RE: City of Eagle Applications Nos. 63-32089 and 63-32090

**PROPOSED CONDITIONS FOR
PERMIT NOS. 63-32089 and 63-32090**

Subject: **Request for Staff Memorandum in Response to Staff Review of Technical Report Entitled *City of Eagle, Idaho, 7-Day Aquifer Test***

Figure 10: Eagle-area ground-water withdrawals, 1993-2002.

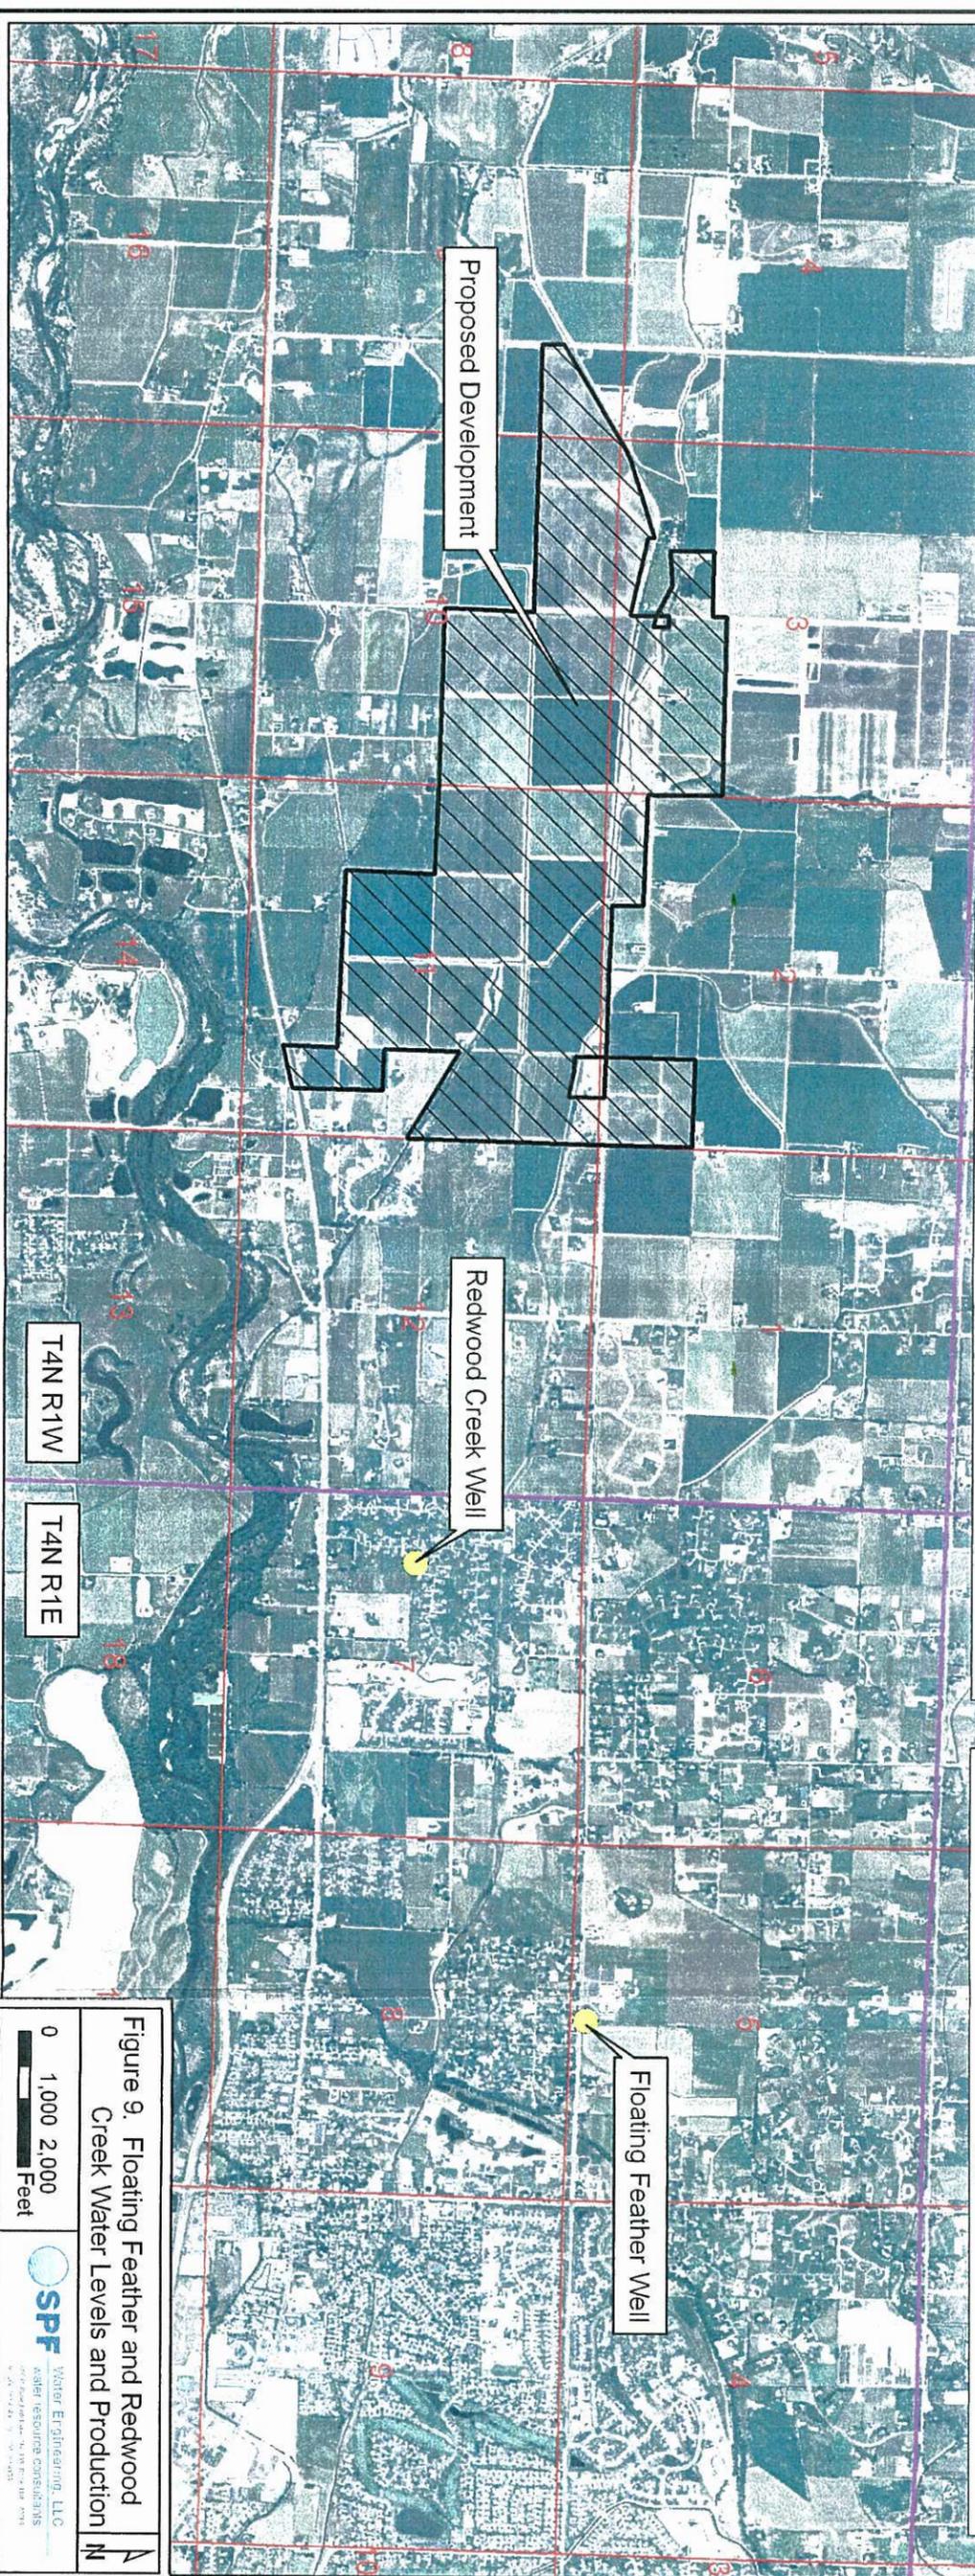
Figure 10 of the *Addendum* (p. 30) is not current. Data through 2006 would have been helpful to determine whether groundwater withdrawals are continuing to increase or have instead stabilized. If groundwater withdrawals have continued the increasing trend shown from 1993 to 2001 in Figure 10, then the appropriation proposed by the City combined with all other withdrawals could very well result in injury to existing water rights. Figure 10 should have been updated with recent data so that the Hearing Officer could make an informed decision. Without such information, no informed decision can or should be made.

Water Level Elevation City of Eagle Aquifer Test

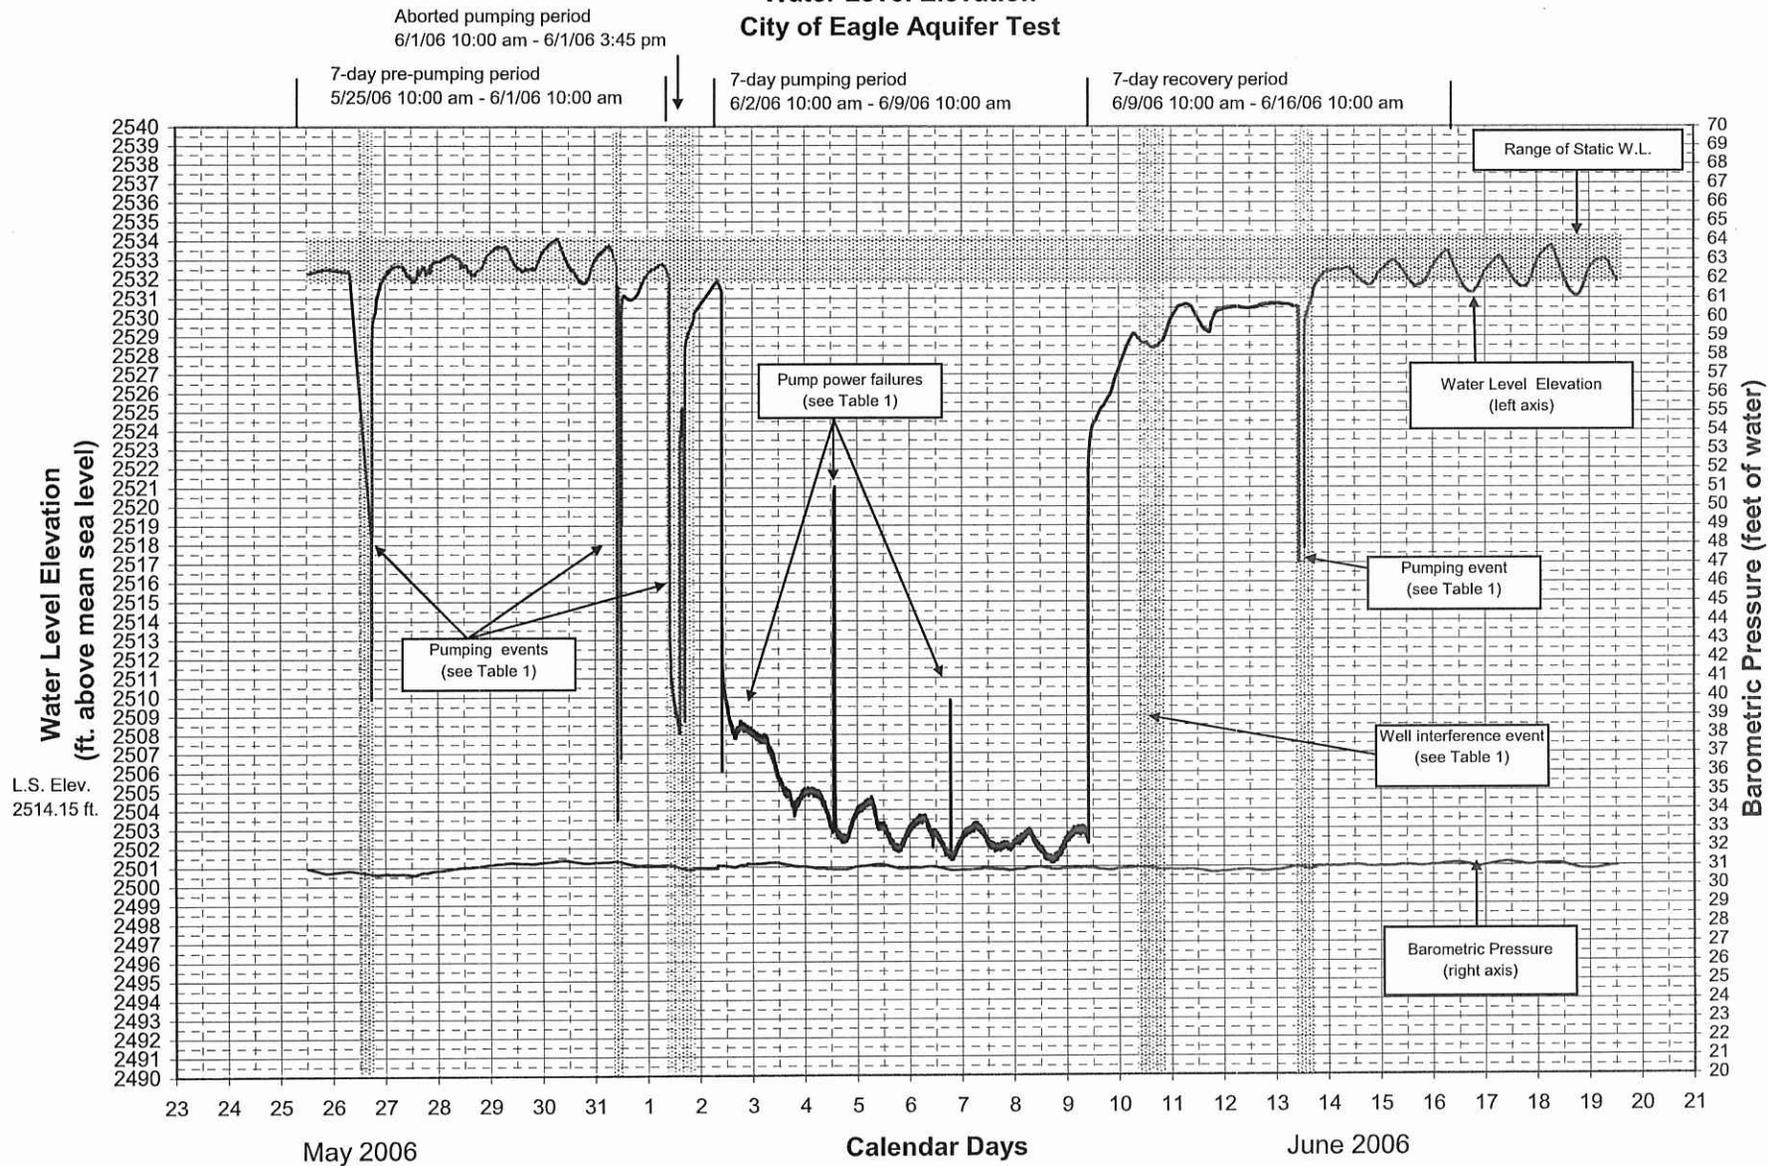
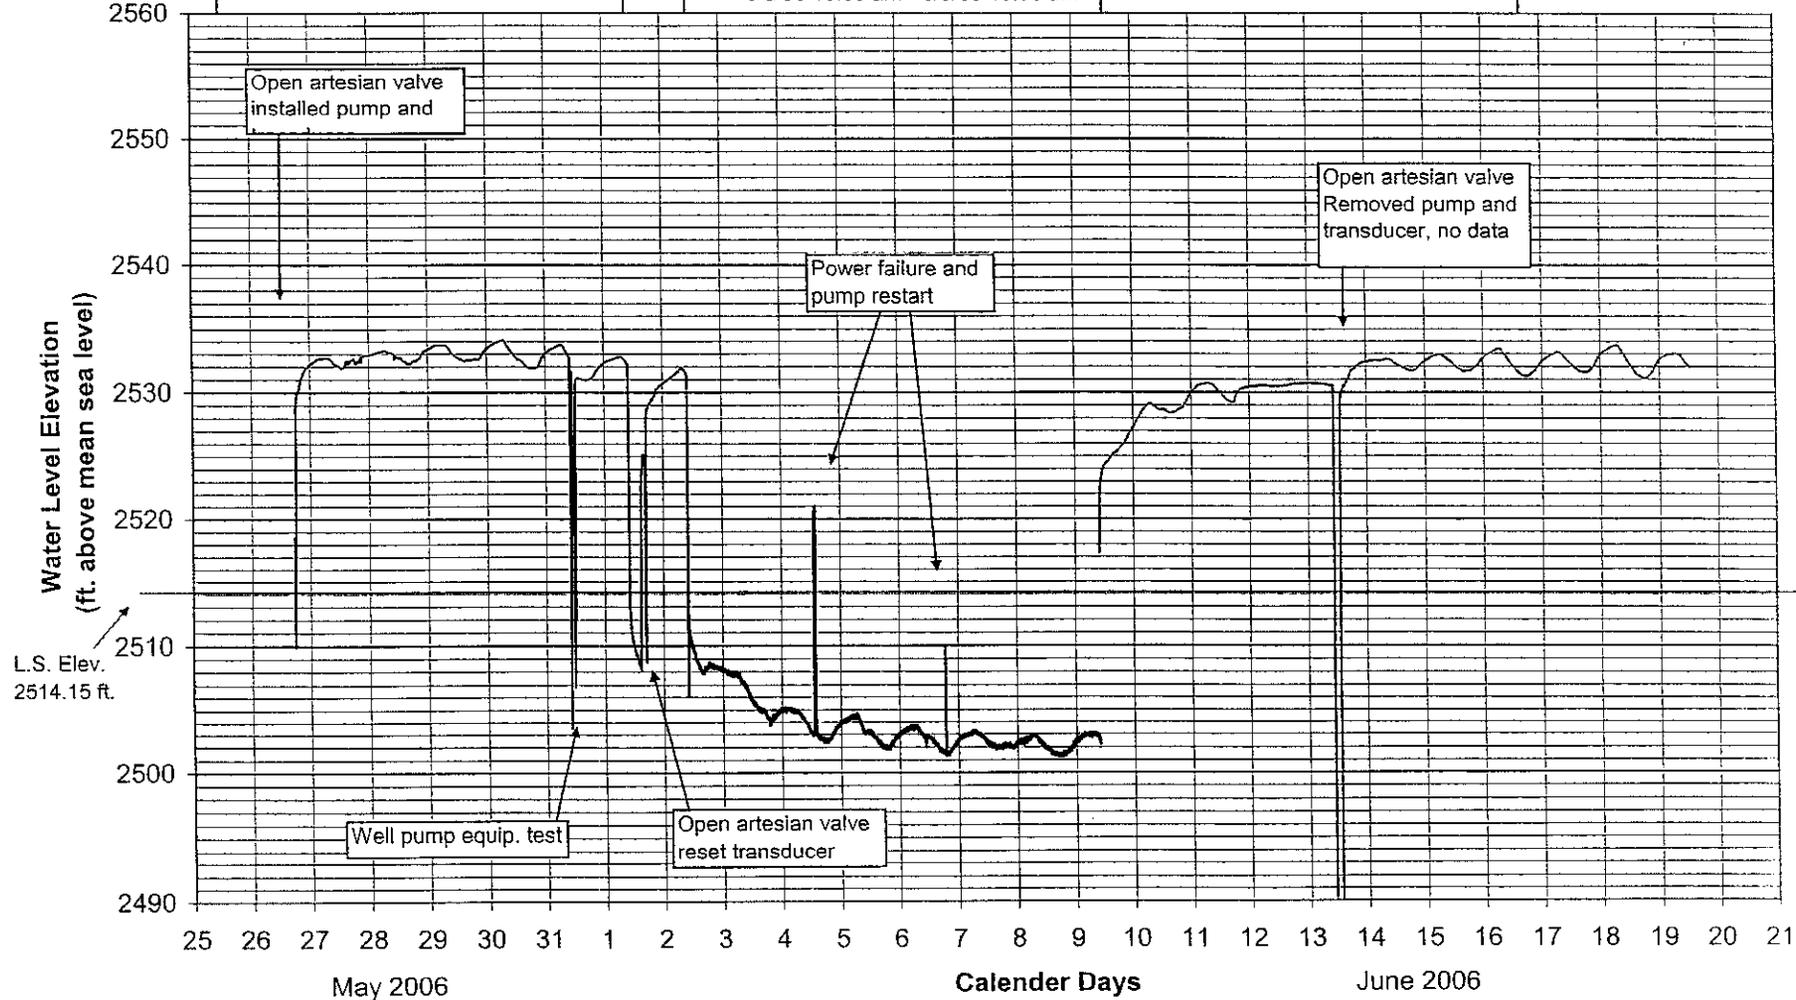
Individual Water Level Elevation graphs for each well attached to the *Addendum* show an event on June 10 identified as “well interference event (see Table 1)”. *Addendum*, Appendices C.3, C.4, C.5, etc. Although Table 1 is referenced on the graphs, neither it nor any other part of the *Addendum* or the *7-Day Aquifer Test* report address this well interference event. The event or events stopped recovery from June 10 until June 13th in the pumping well, Legacy well, QCR4, and Strata 1B well. The Water Level Elevation graph for Strata 1A well did not show significant drawdown so impact from the “well interference event(s)” was not noticeable in that well.

Monitoring Well No. 11 (UWI 1A South)

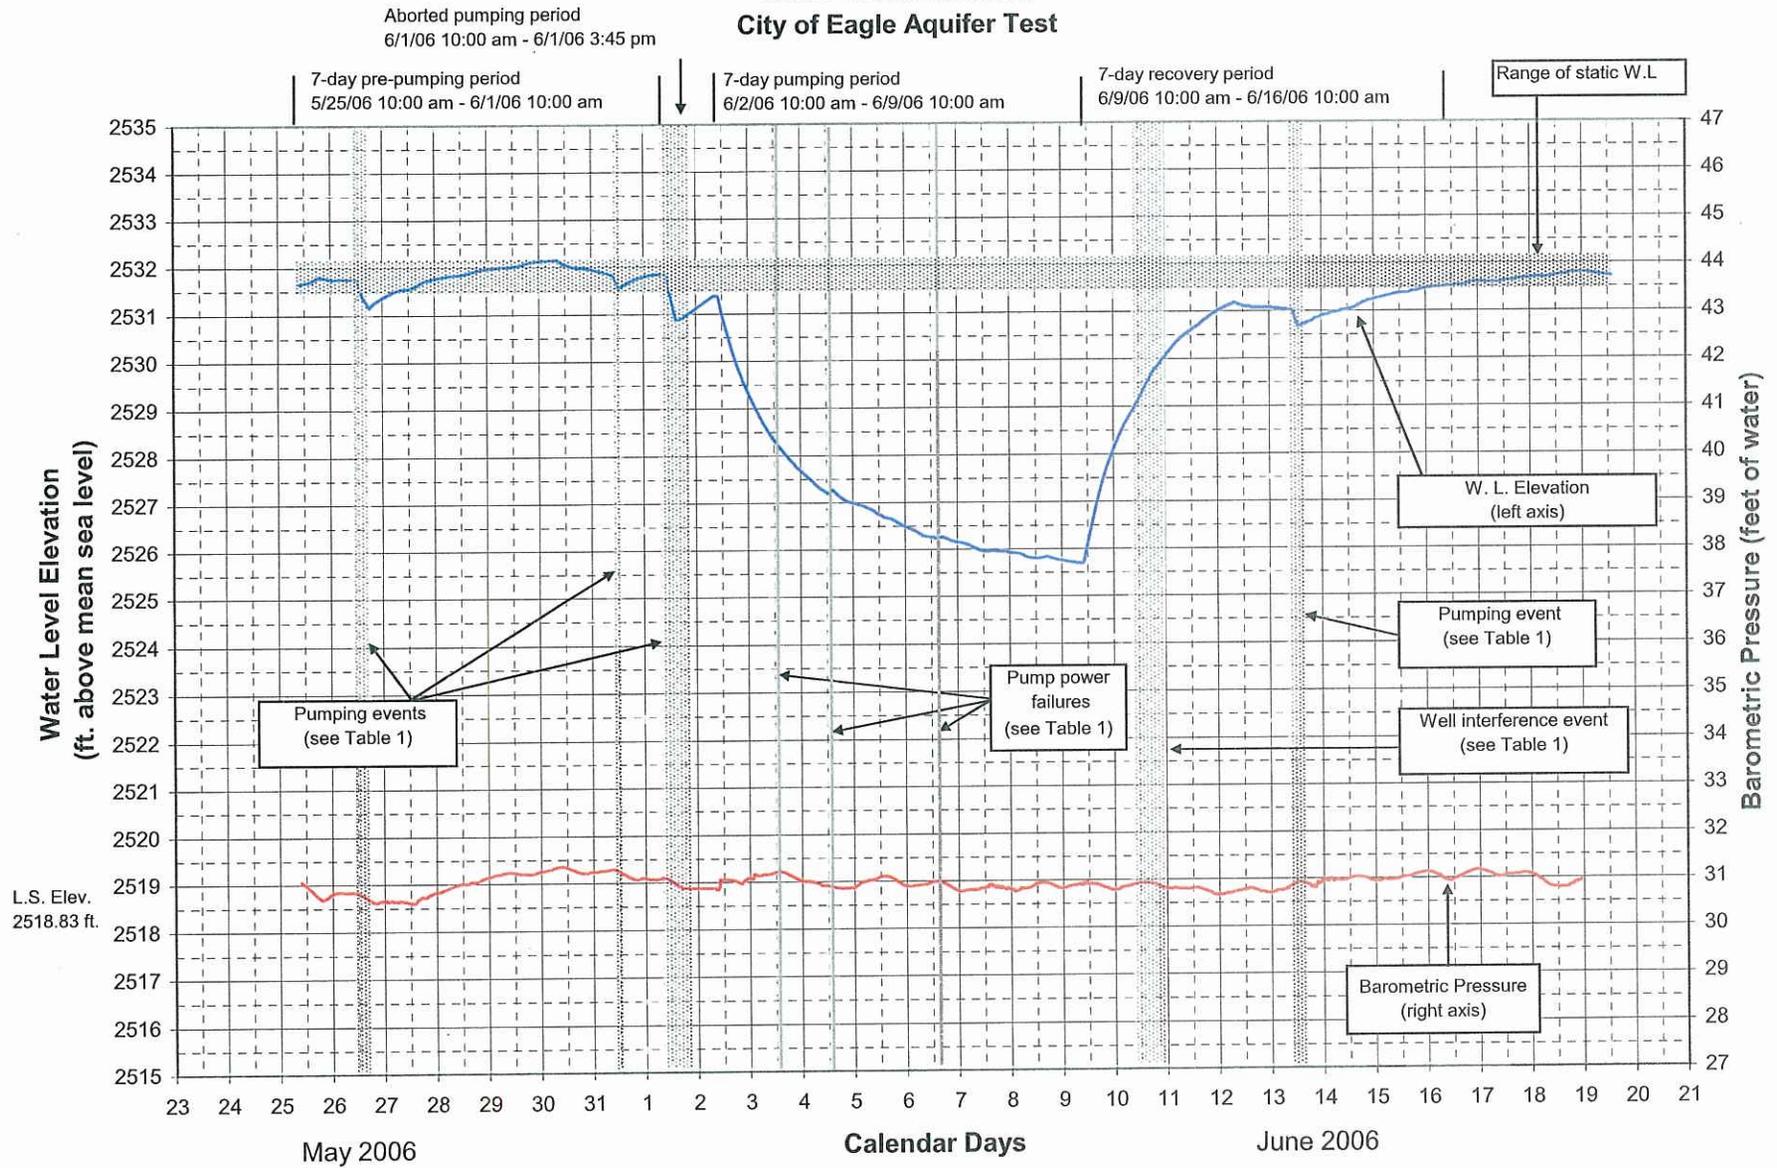
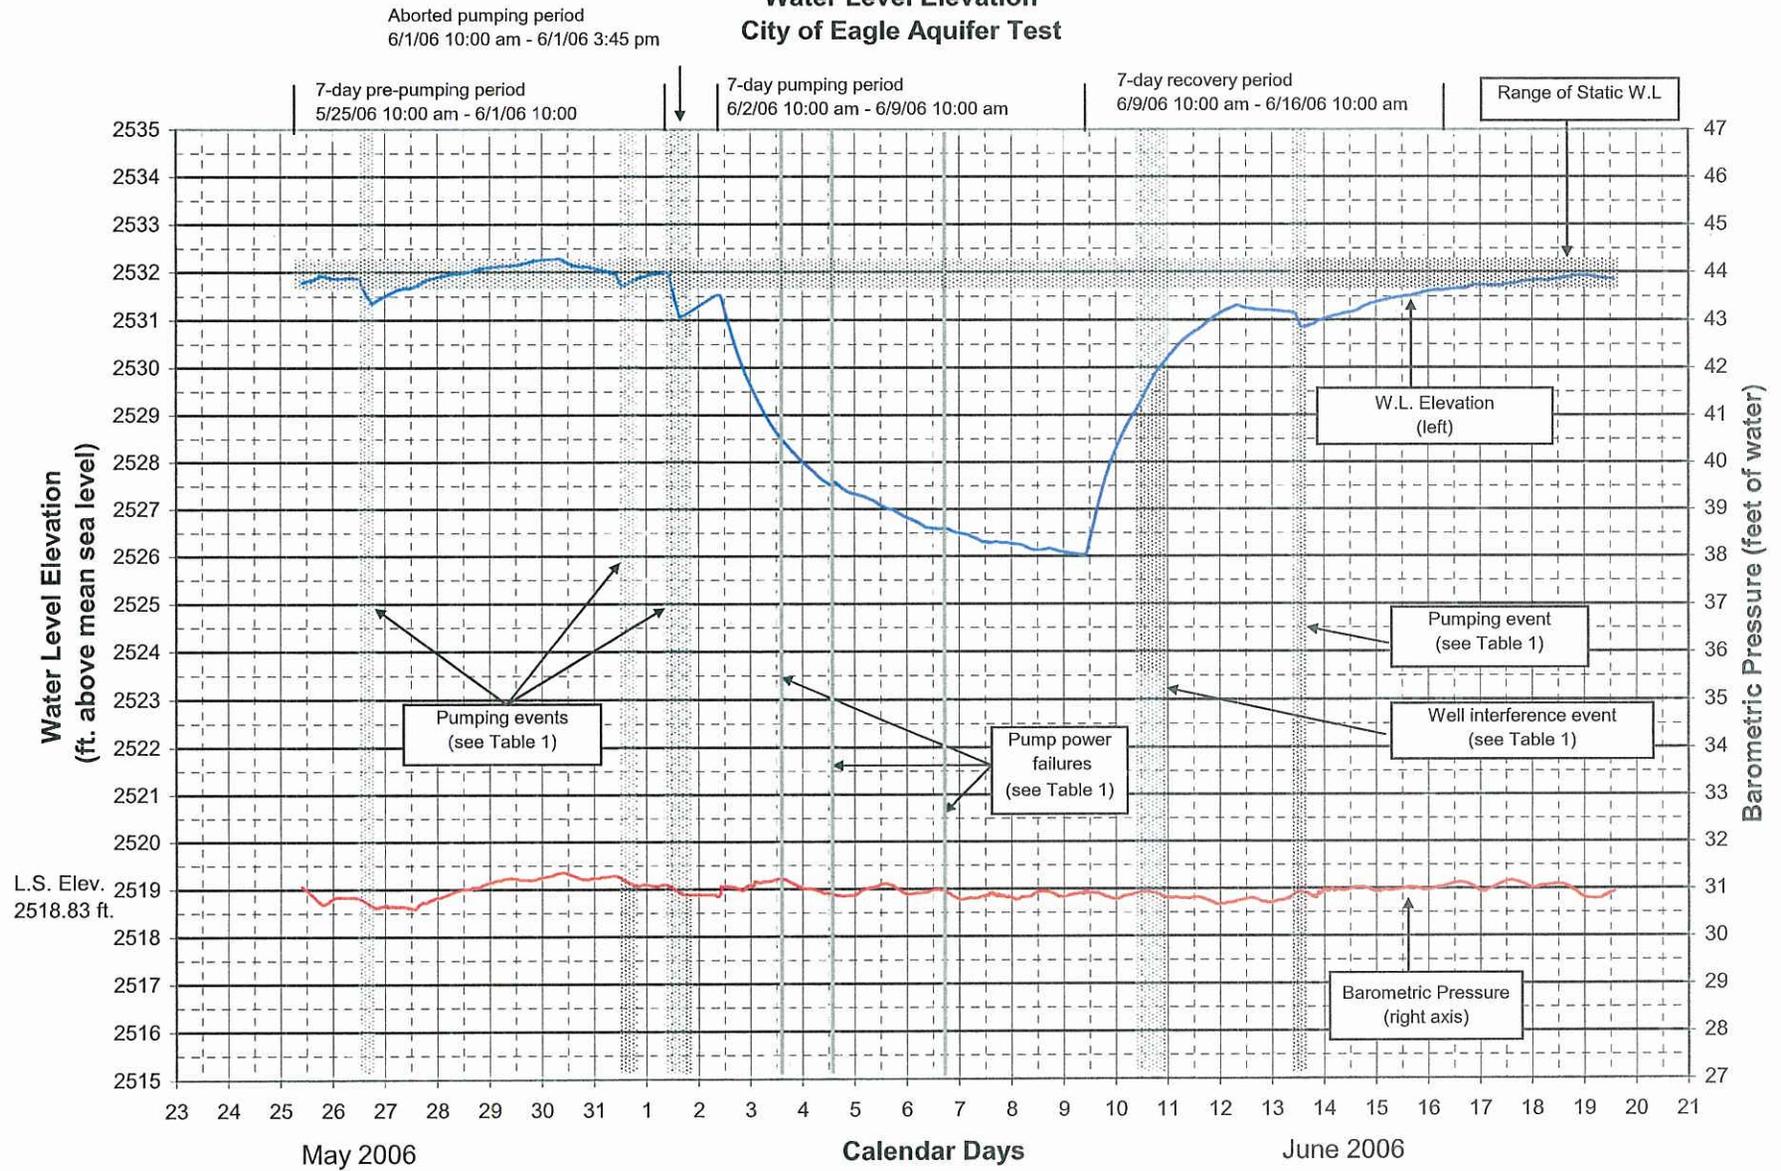
The Water Level Elevation graphs for UWI wells 1A and 1B didn't show any impact on recovery on June 10, but an event prevented drawdown recovery in those wells from about June 12th
